Zusatzanleitung H09P
Modell2006-
additional manual H09P
model2006-

Achtung ! Modell ab 2006-
rechts:

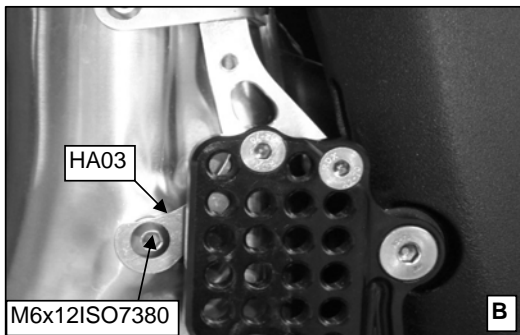
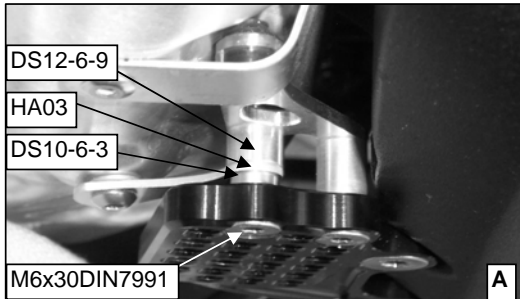
- hintere DS11-6-14 durch mitgelieferte DS12-6-9 Halter HA03 und DS10-6-3 ersetzen.(A)
 - Halter ausrichten und Auspuffblende mit Schraube M6x12ISO7380 befestigen.(B)
- Anzugsdrehmoment: 10Nm**

- replace DS11-6-14 with add. DS12-6-9 holder HA03 and DS10-6-3.(A)
 - adjust HA03 and fix exhaustcover with screw M6x12ISO7380.(B)
- tightening torque: 10Nm**
